SUBJECT: Forwards response to NRC 861202 request for addl info re
 piping stress analysis damping values, including util
 response to NRC comments, proposed revs to FSAR & util 700605
 ltr transmitting seismic spectra info.

H. B. ROBINSON STEAM ELECTRIC PLANT, UNIT NO. 2
DOCKET NO. 50-261/LICENSE NO. DPR-23
PIPING STRESS ANALYSIS DAMPING VALUES

Carolina Power & Light Company (CP&L), by submittal of Reference 1, requested approval to utilize the damping curve developed by the Pressure Vessel Research Council (PVRC) in ASME Code Case N-411. This letter is in response to the request for additional information and commitments identified by Reference 2. The FSAR changes and accompanying commitments have been restructured from the original submittal. To avoid possible confusion, this letter supersedes the previous submittal in its entirety.

Figure 3.7.2-7

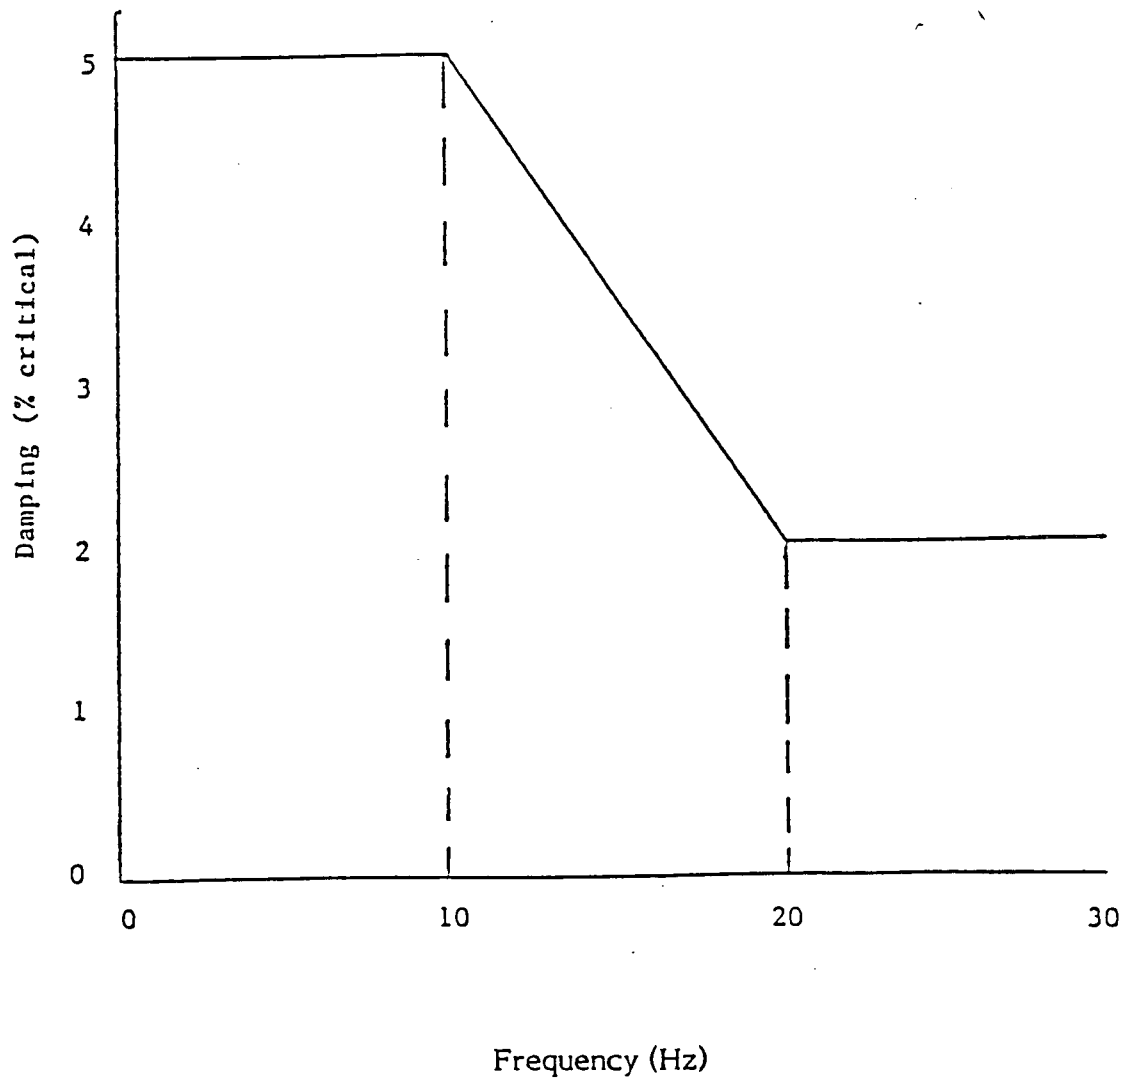
- NRC COMMENT #1 The damping values specified in Code Case N-411 may be used only in those analyses where current seismic spectra and procedures have been employed. The 0.1g and 0.2g Housner spectrums which are identified in Figures 2.5.2-2 and 2.5.2-3 of the H. B. Robinson, Unit 2 Updated FSAR cannot be considered as "current".

- NRC COMMENT #5 The damping values specified in Code Case N-411 may be used only in analyses which assume an upper bound envelope of the individual response spectra for all support locations to calculate maximum inertial responses of multiple-supported items.

The damping values given in Figure 3.7.2-7 may be used as an option only if the following criteria are applied in addition to those previously listed in 3.7.3.2.9.

- a) A response spectrum analysis is performed and not a time history analysis.
- b) The alternate damping values will be used only for piping.
- c) The alternate damping values will not be used to analyze piping systems using supports designed to dissipate energy by yielding.
- d) The alternate damping values will not be used in conjunction with multi-level excitation.
- e) The alternate damping valves will not be used in analyzing piping systems in which stress corrosion cracking has occurred.
- f) Application of these damping values will be separately identified in each calculation

The optional damping values for piping in Table 3.7.2-1 and Figure 3.7.2-7 may be used if the criteria in 3.7.3.2.9.1 is followed.

* For final reconciliation of pipe stress analysis, piping system backfits, or new piping damping values as define in ASME Code Case N-411 (Figure 3.7.2-7) may be utilized for ~~both OBE and~~ DBE.
